UNITED STATES PATENT AND TRADEMARK OFFICE

APPLICATION NO.	FILING DATE	FIRST NAMED INVENTOR	ATTORNEY DOCKET NO.	CONFIRMATION NO.
10/784,454	02/23/2004	Dennis Conklin	4281-A11	8216

Office Action Summary

FIG. 2

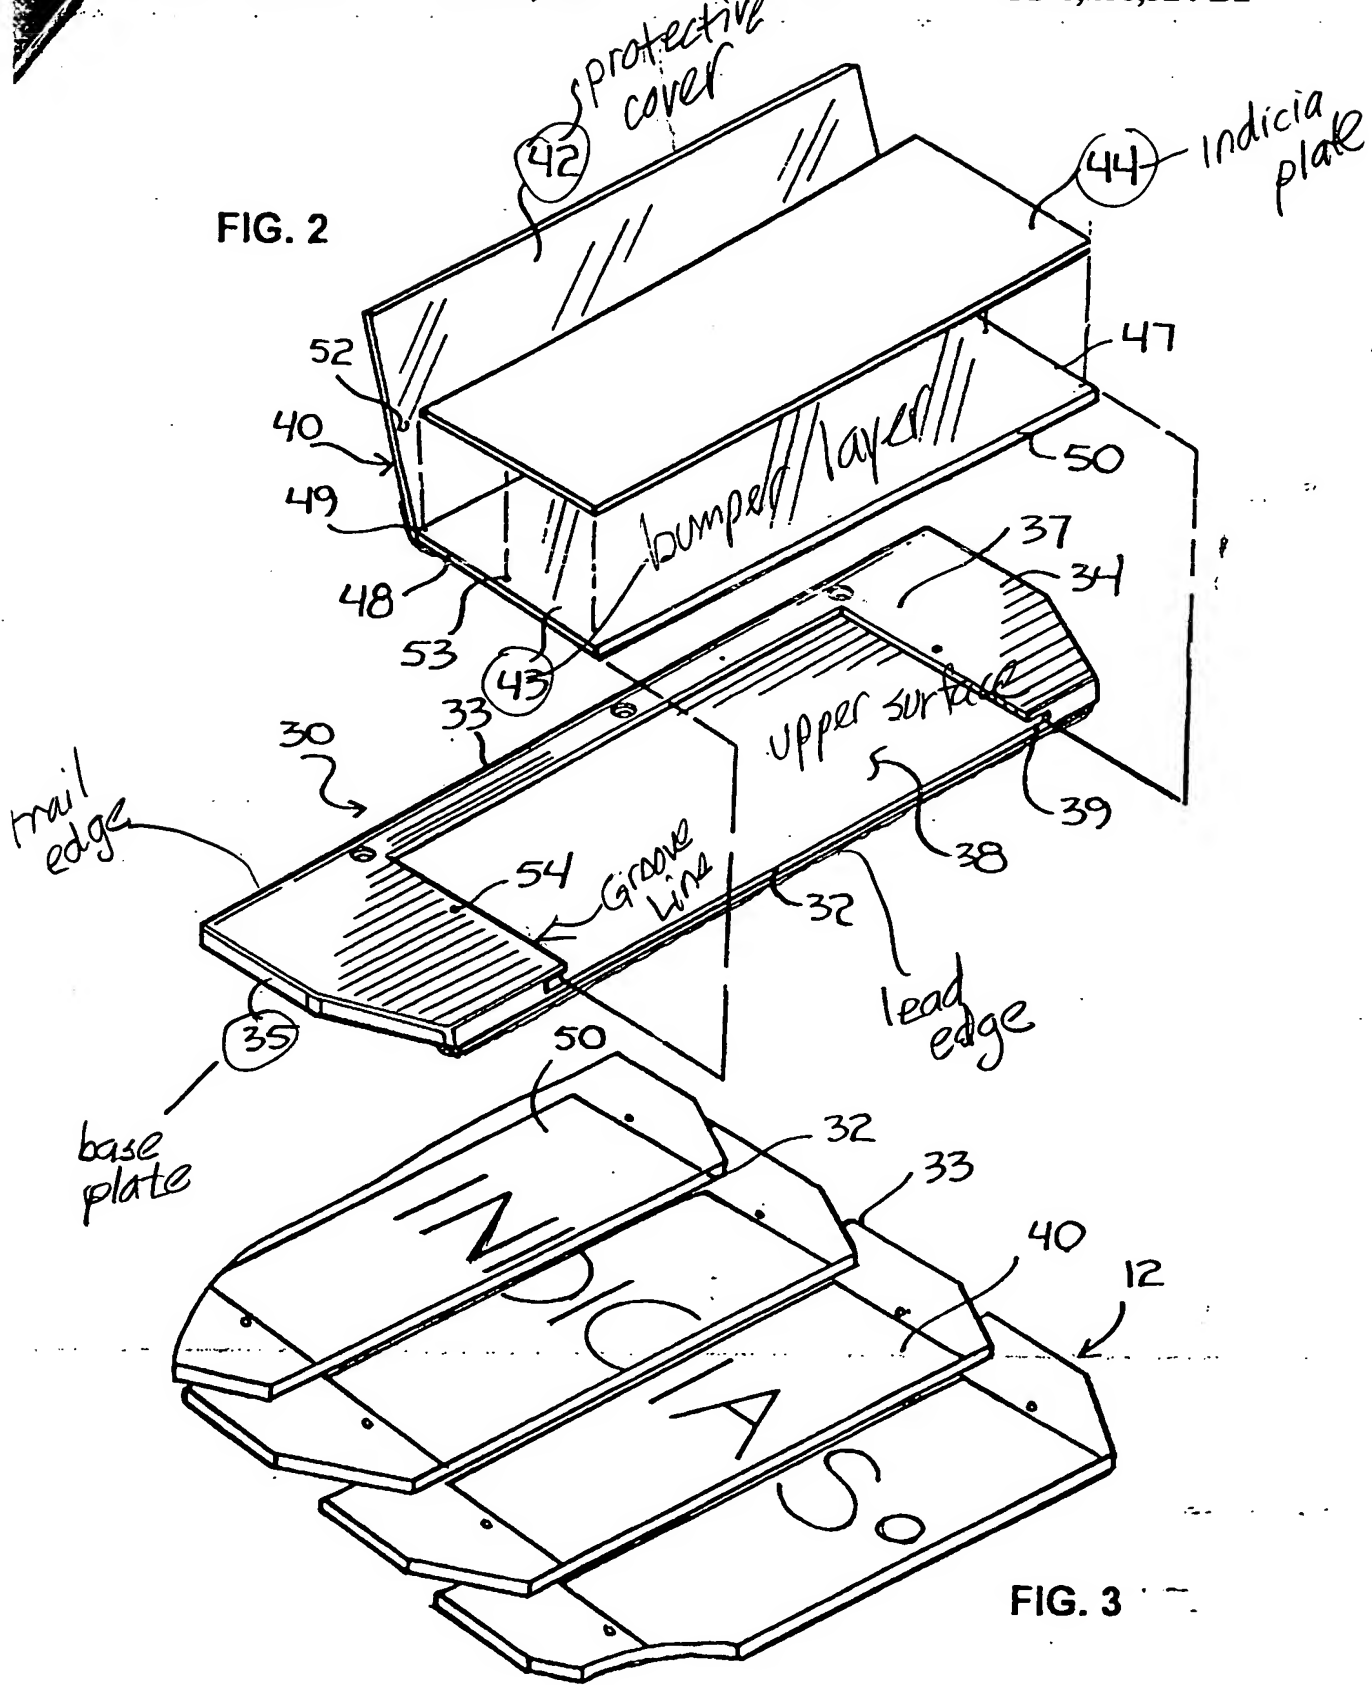
10. Claims 7, 11-13, 16, and 19 are rejected under 35 U.S.C. 102(e) as being anticipated by Conklin, Jr. (US Pat. 6,186,314).

See the attached marked up drawing figure 2 of Conklin, Jr. depicting the claimed features.
